Imray Correction Notice

2000 Series small format charts

IC2000-6

09 November 2020

RIVER ORE ENTRANCE

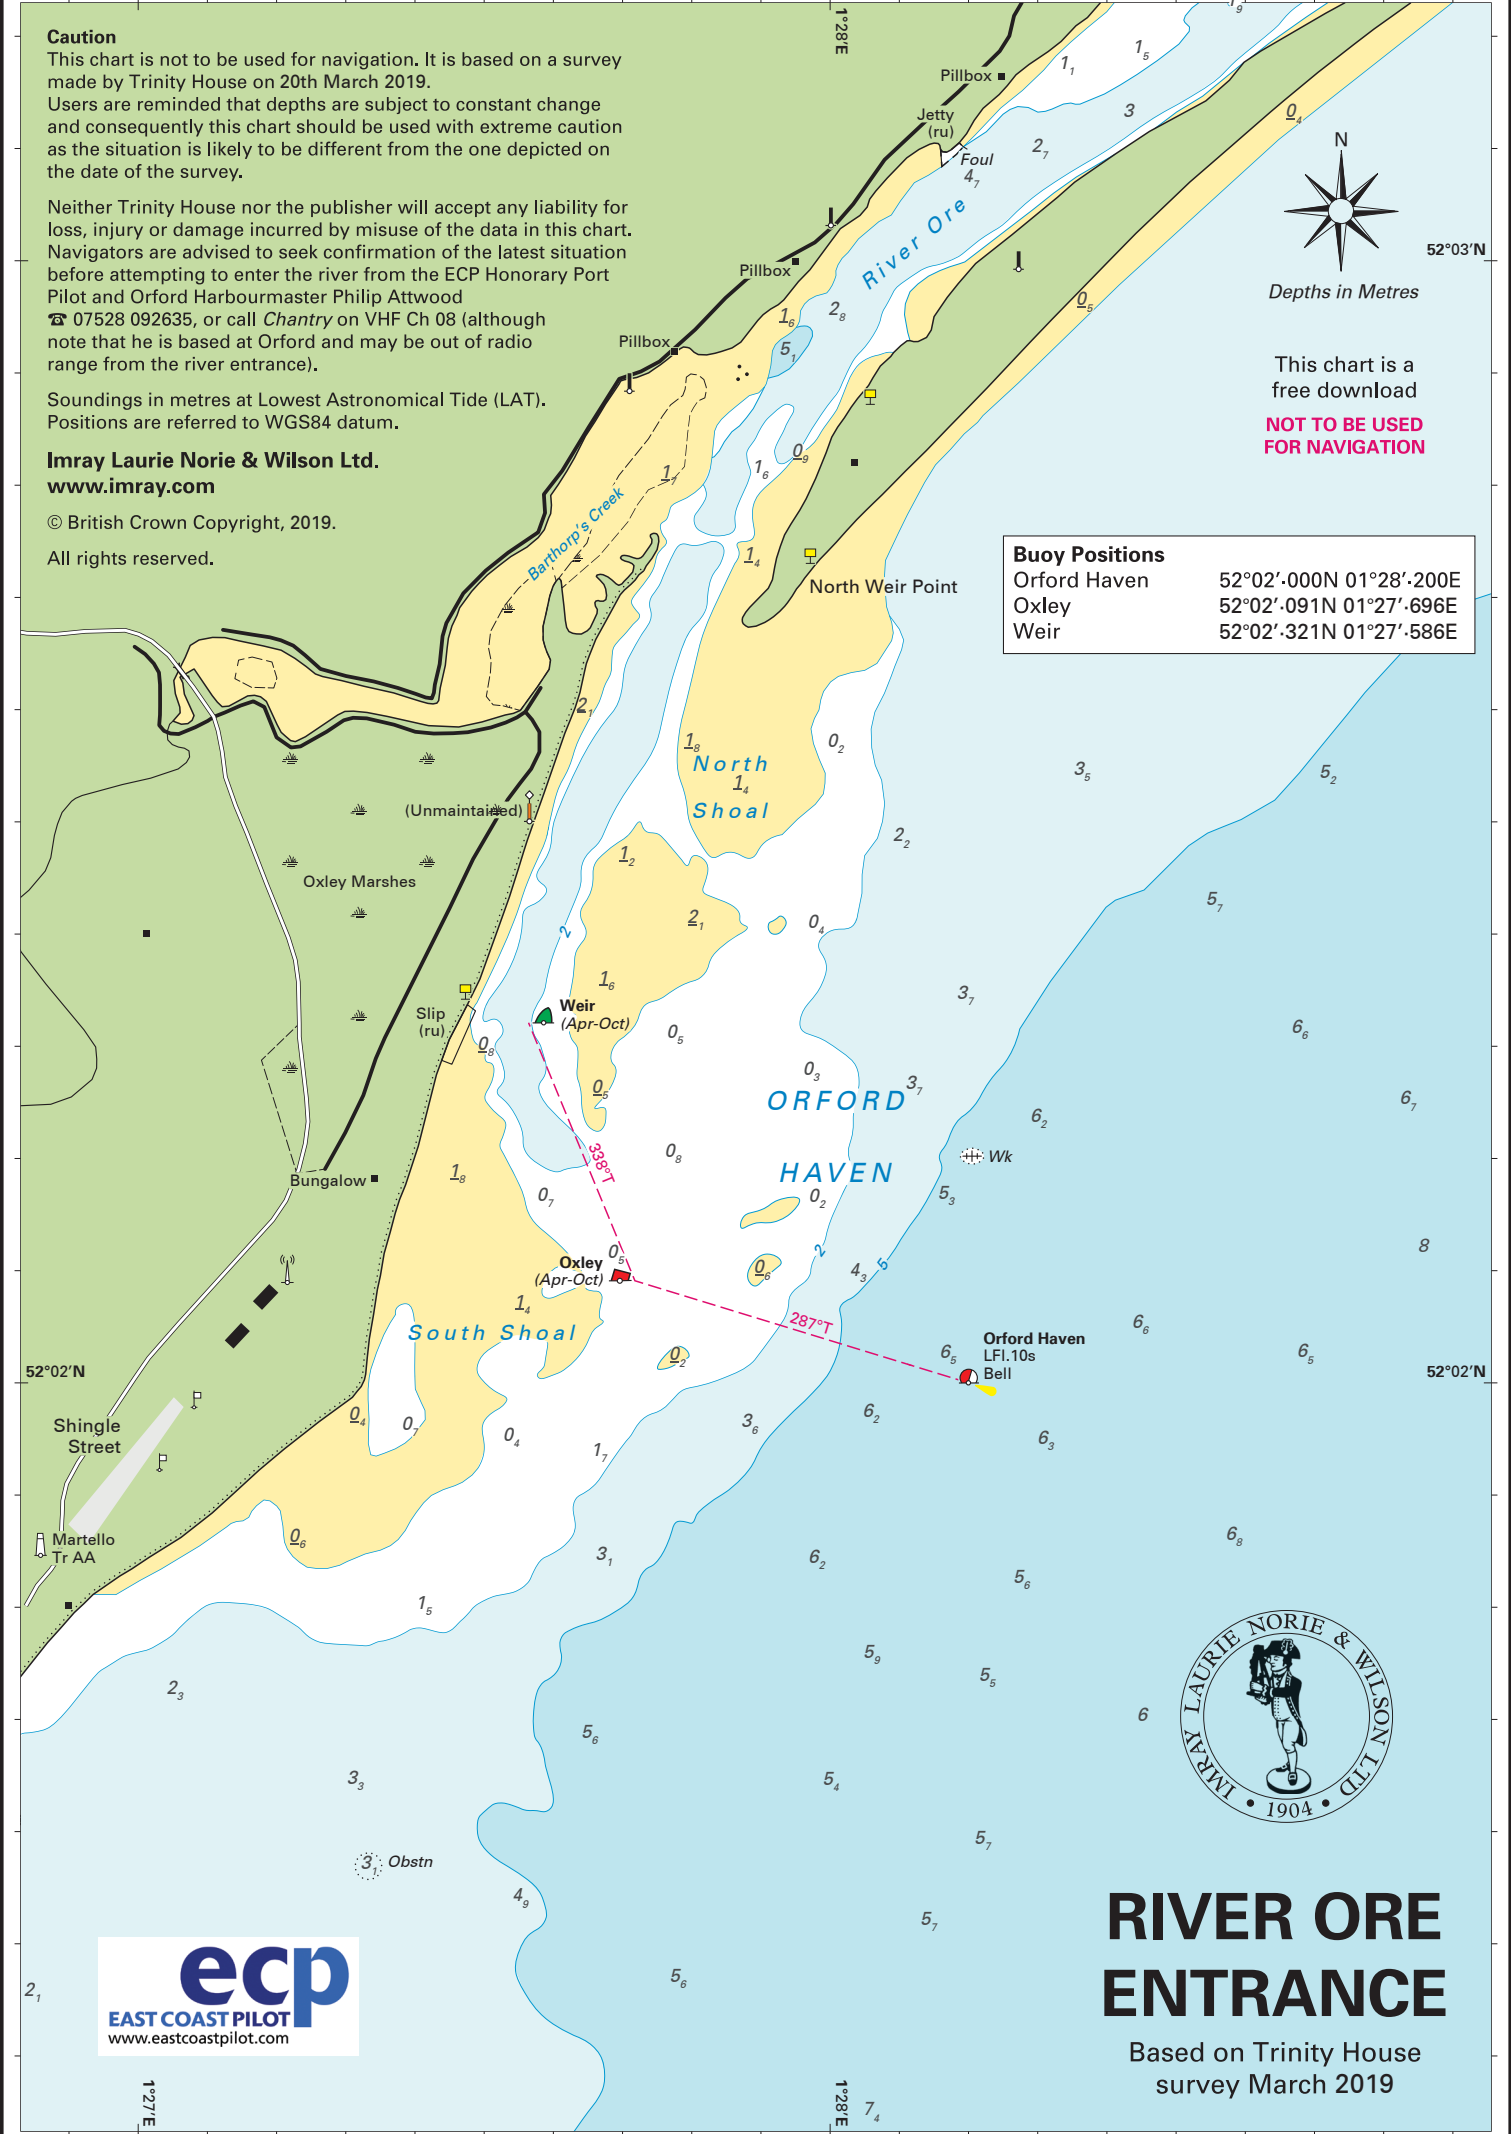
Move G con. buoy **Weir** to 52°02'·32N 1°27'·59E

For detailed information about the River Ore entrance yachtsmen are advised to consult the accompanying chartlet (revised 03/19) (ILNW 170/19)

G con. buoy **Weir** to 52°02'·22N 1°27'·56E

Move G con. buoy **Weir** to 52°02'·20N 1°27'·58E (ILNW 366/20)

Orford Haven	52°02'.000N 01°28'.200E
Oxley	52°02'.091N 01°27'.696E
Weir	52°02'.321N 01°27'.586E

RIVER DEBEN ENTRANCE

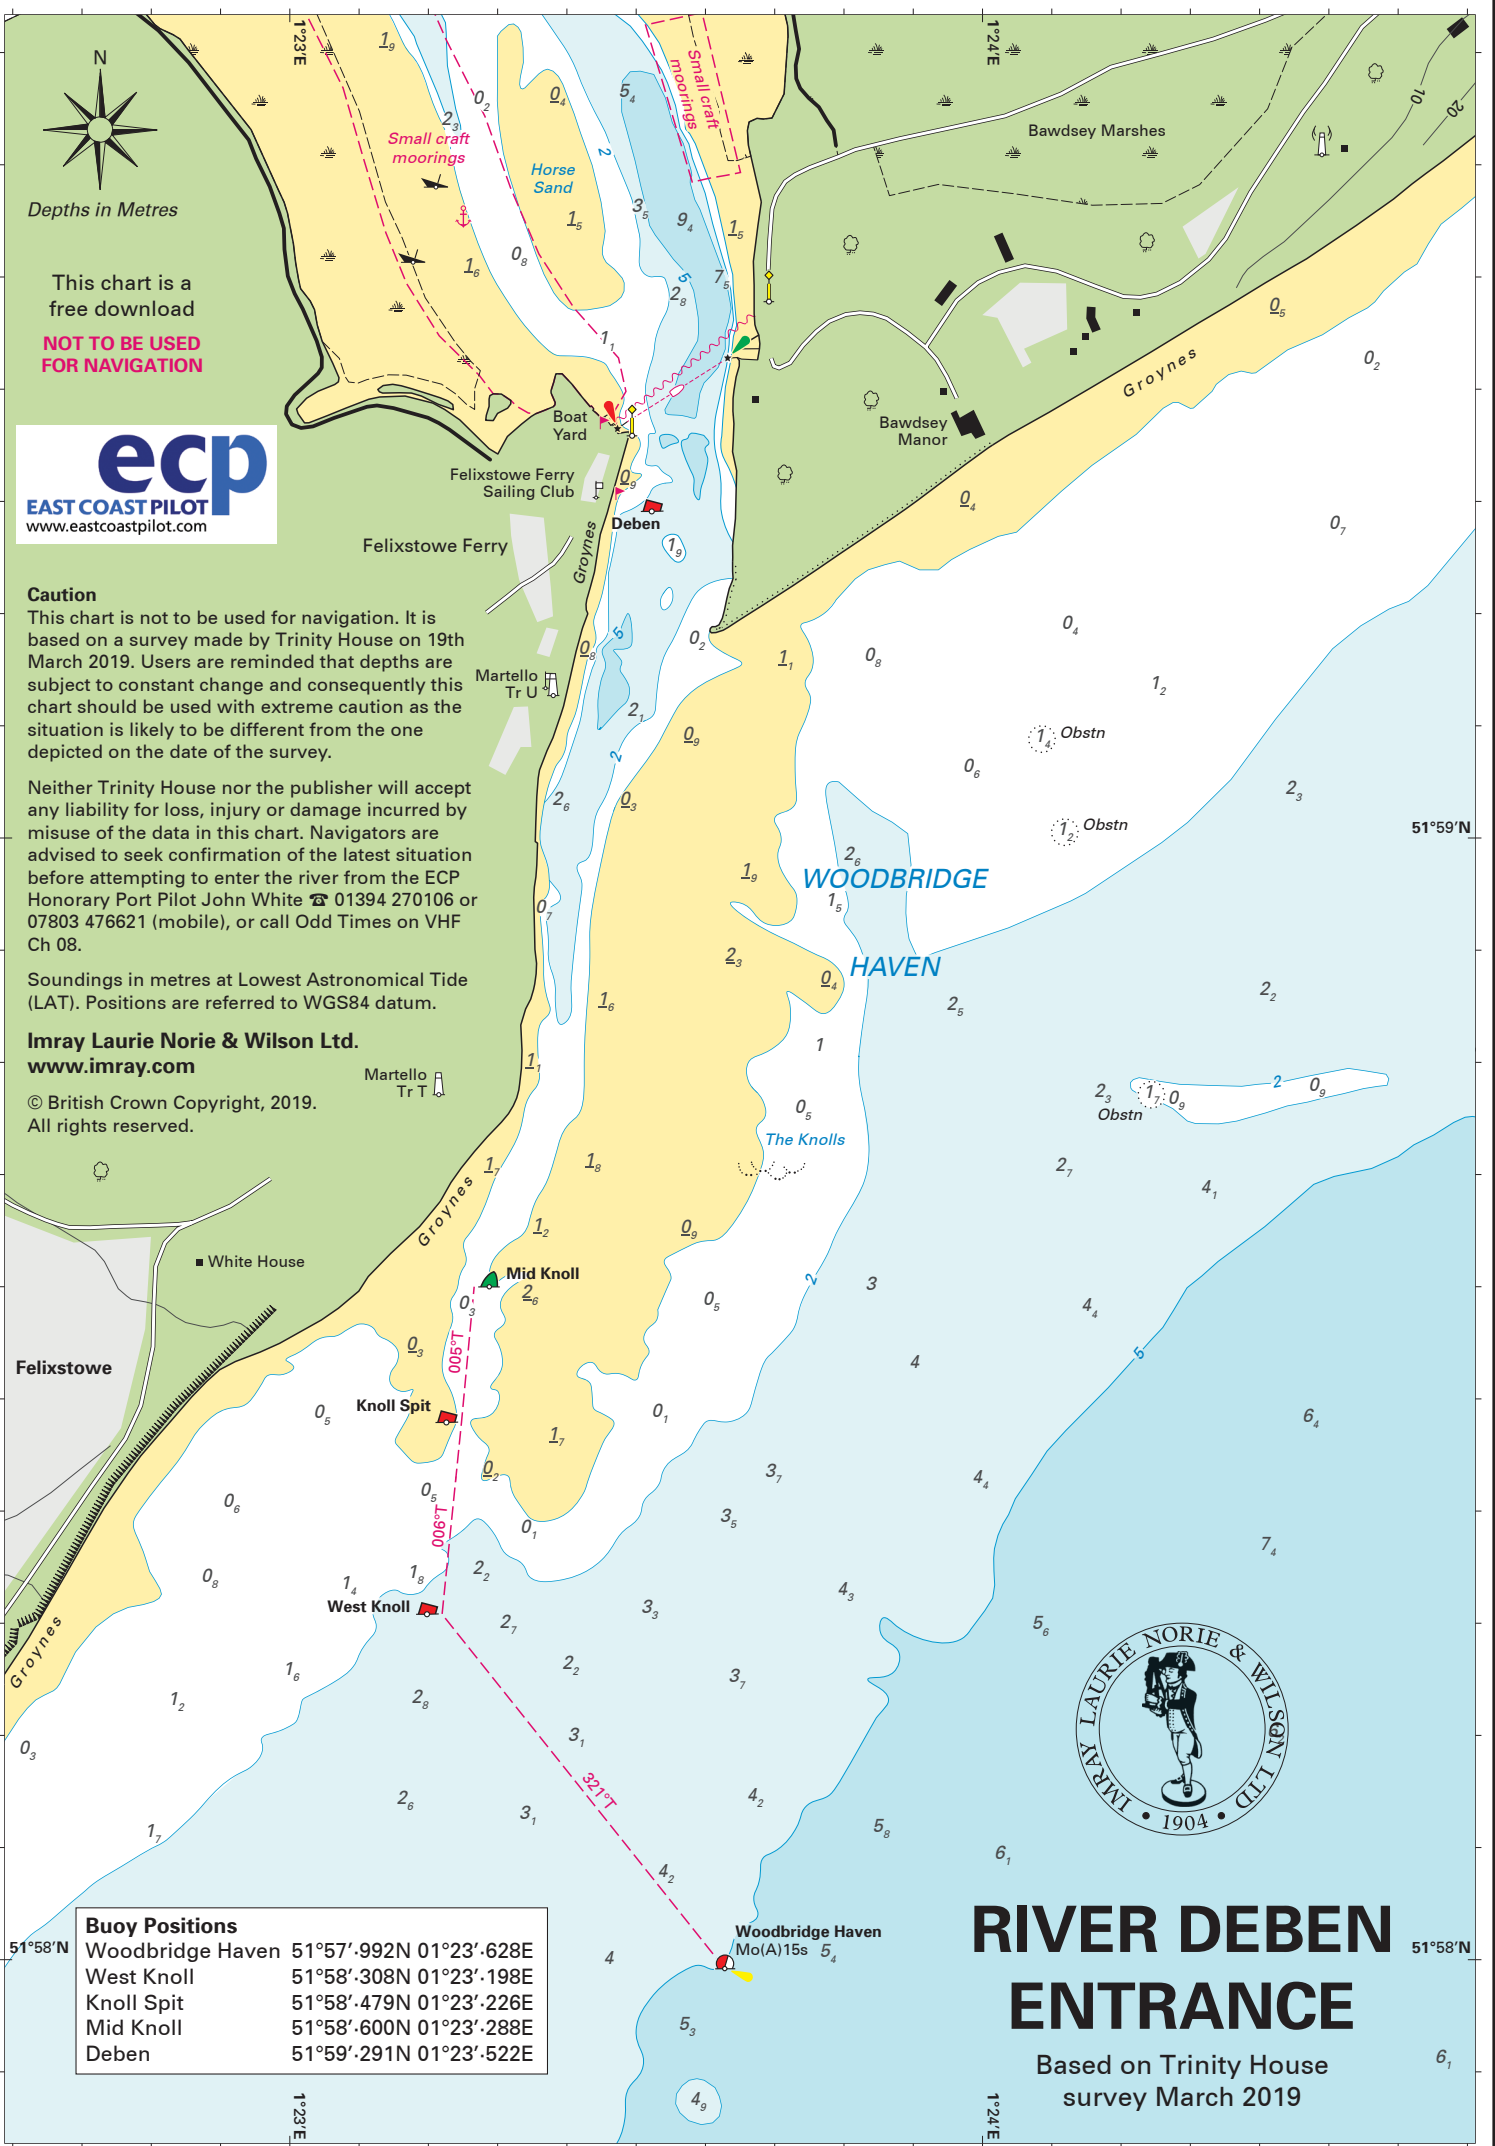
R can buoy **Knoll Spit** to 51°58'·48N 1°23'·23E

G con. buoy **Mid Knoll** to 51°58'·60N 1°23'·29E

For detailed information about the River Deben entrance yachtsmen are advised to consult the accompanying chartlet (revised 03/19) (ILNW 171/19)

G con. buoy **Mid Knoll** to 51°58'·58N 1°23'·24E

R can buoy **Knoll Spit** to 51°58'·52N 1°23'·18E

R can buoy **West Knoll** to 51°58'·43N 1°23'·07E

Buoy Positions	
Woodbridge Haven	51°57'.992N 01°23'.628E
West Knoll	51°58'.308N 01°23'.198E
Knoll Spit	51°58'.479N 01°23'.226E
Mid Knoll	51°58'.600N 01°23'.288E
Deben	51°59'.291N 01°23'.522E
